## Staff Report

**DP 04-280263**

4. Mixed Use Commercial Residential  
*Kenneth King Arch.*  
6780 No. 4 Road  
(Formal)

DP1  
granville place  
mixed use development  
6780 no 4 road, richmond  
Kenneth E. King  
Architecture Planning/Urban Design  
+ Interior Design  
1937 Hopson Avenue, Burnaby V5B 3W4

PLAN #2

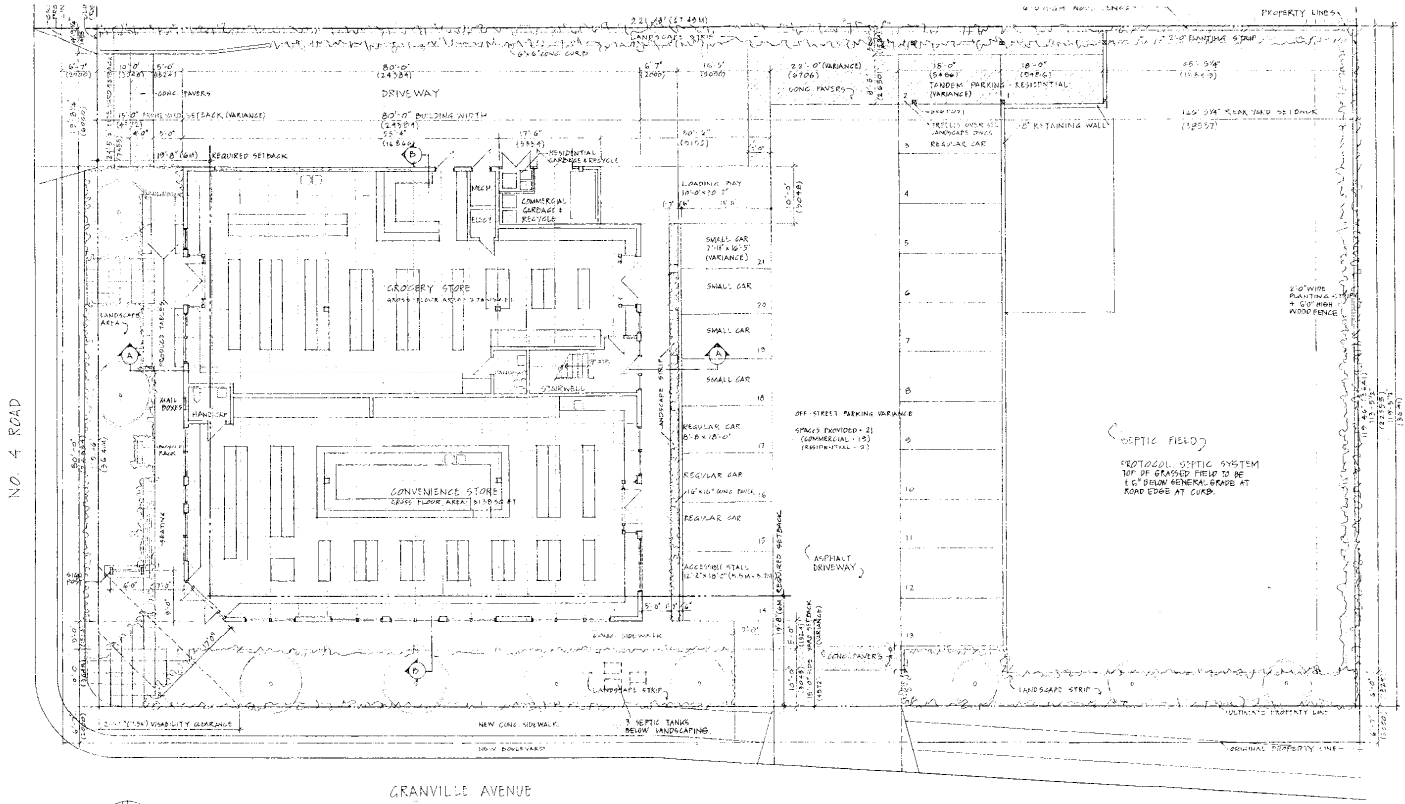
- incorporation of planting strip between the building and the driveway;

*(As the septic field location and size for the present and future replacement field is at its optimum size, a large planting strip is not possible. An 18-inch wide landscape strip with low planting is proposed with a concrete wheel curb as shown on Plan #2)*

Plan # 3

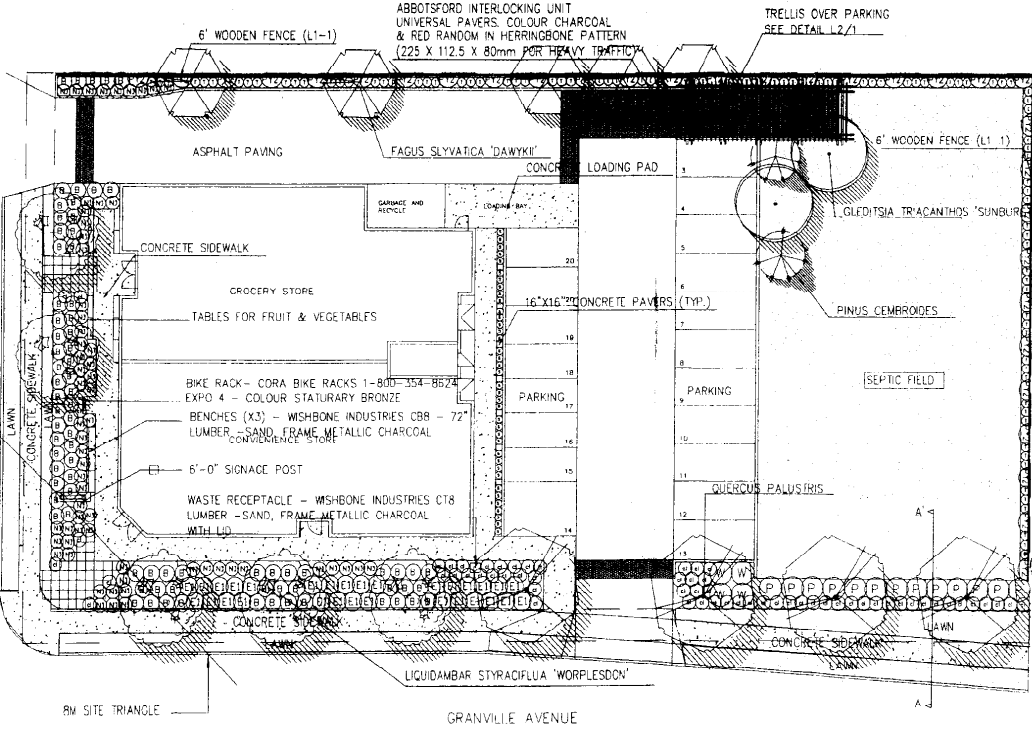
- consider incorporating a trellis over the residential parking;  
*(A trellis has been incorporated over the residential parking)*
- improve streetscape treatment along the boulevards; and  
*(Streetscape treatment along the boulevards has been revised – refer to the landscape plan on Plan #3)*

PLAN #4

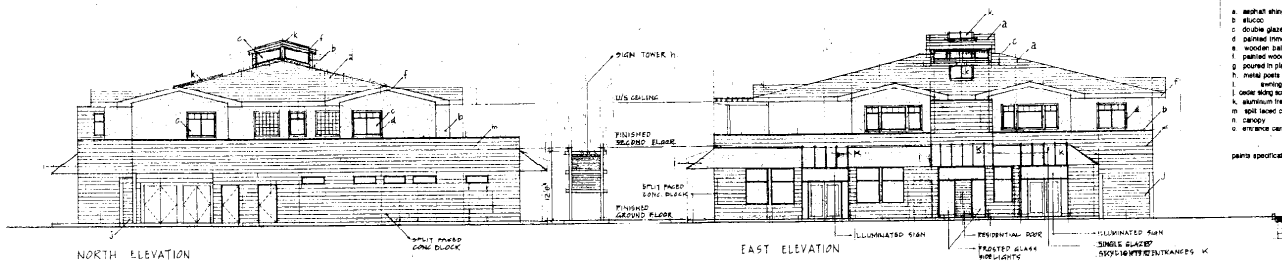
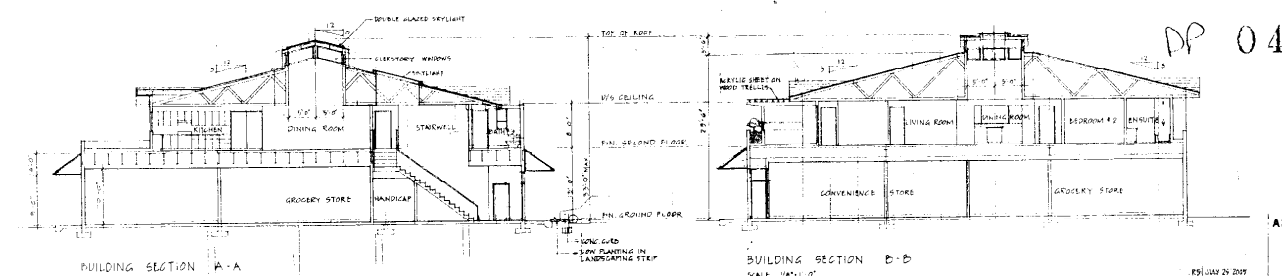
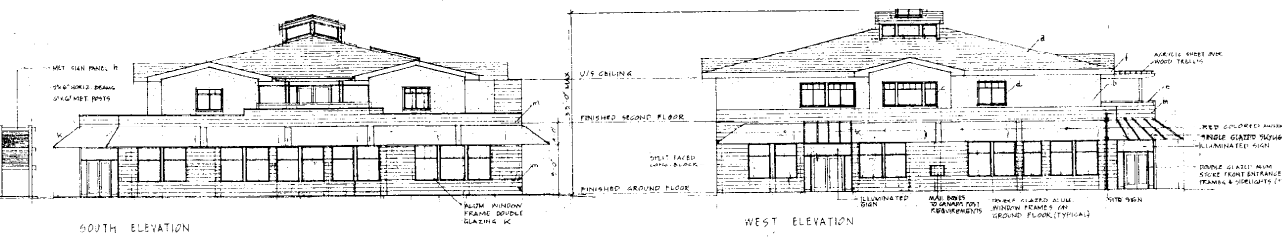
- creation of a more cohesive architectural expression by improving the awning material/colour and by carrying some of the architectural elements from the ground floor to the second floor;

- create architectural cohesiveness between the upper and lower floors;  
*(Architectural cohesiveness between the upper and lower floors is created at the residential entrance area (east elevation) with the concrete block projecting through two floors)*

*(The split face concrete block walls extend up to the curb above the second floor – a height of about 15 ft. above the ground floor. The stucco faced second floor walls are set back from the concrete block wall 10 to 15 ft. on the west and south facades respectively and 5 to 10 ft. on the east façade except at the residential entrance. The split face concrete block wall has been carried up to the eave of the second floor roof. The design and colour of the canopy has been revised to include a continuous canopy consisting of coloured panels with glass sections above building entrances)*
